Title: Advisory Committee on Reactor Safeguards
Early Site Permit Subcommittee

Date: Wednesday, March 8, 2006

EARLY SITE PERMIT SUBCOMMITTEE MEETING

Conclusion 2 (Cont.)

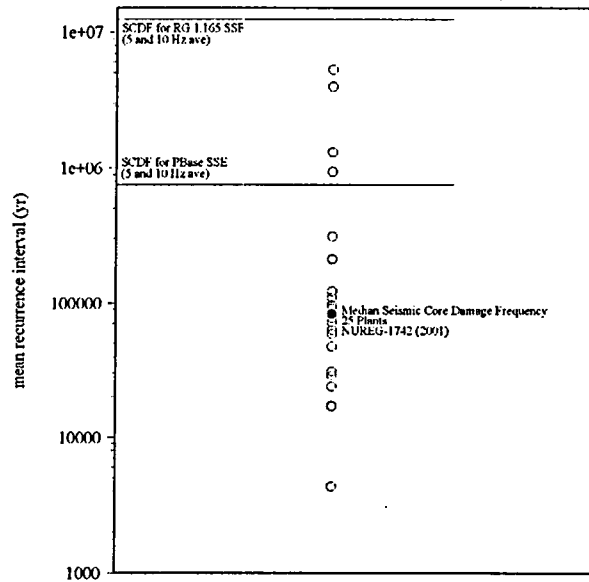
22 DR. BONACA: But doesn't Figure 29 -- the
23 Figure 29 shows that the performance based approach is
24 still conservative with respect to the current plants,
25 but not as conservative as the one on Reg. Guide
